Access Compliance Report

Public Rights-of-Way (Curb Ramps)

Intersection ID: 10023017	Main Street: CENTER_PARK_DR	Cross Street: N/A	Location: SW
ADA ID: CBF1D2B30860	Ramp Type: Directional2	Initial Pass/Fail: Fail	Overall Compliance: No
Severity Score: 42.5			
Codes/Mitigation Info/Possible Solution		Field Measurements/Component Compliance

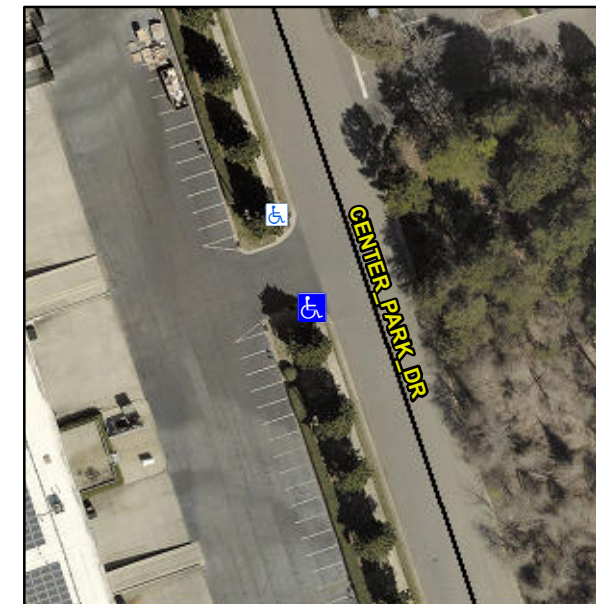
R304.5.1, R304.5.3

Compliance	Description	Data	Compliance	Description	Data
N/A	Ramp Length (in)	64.0	N/A	Grade Break?	N/A
No	Ramp Width (in)	33.0	N/A	Grade Break Slope (%)	0.0
Yes	Ramp Slope (%)	3.2	N/A	Grade Break XSlope (%)	0.0
No	Ramp XSlope (%)	11.1			
N/A	Flare Type LT	N/A	N/A	Flare Type RT	N/A
N/A	Flare Slope LT (%)	N/A	N/A	Flare Slope RT (%)	0.0
N/A	Flare Traversable LT?	N/A	N/A	Flare Traversable RT?	N/A
N/A	Landing Length (in)	0.0	N/A	DWS Provided?	N/A
N/A	Landing Width (in)	0.0	N/A	DWS Contrast?	N/A
N/A	Landing Slope (%)	0.0	N/A	DWS Length (in)	N/A
N/A	Landing X Slope (%)	0.0	N/A	DWS Full Width?	N/A
N/A	Landing Curb? (Y/N)	N/A	N/A	DWS Offset LT (in)	N/A
N/A	Shared Landing?	N/A	N/A	DWS Offset RT (in)	N/A
N/A	Gutter Ponding?	0.0	N/A	Gutter Slope (%)	N/A
N/A	Gutter Lip Ht (in)	0.0	N/A	Gutter X Slope (%)	N/A
N/A	Painted X Walk1?	No		Road Slope (%)	2.1
	X Walk 1 Direction	To NW		Road X Slope (%)	9.2
	X Walk 1 Width (in)	N/A		Clear Space?	N/A

Remove & Replace Entire Ramp.
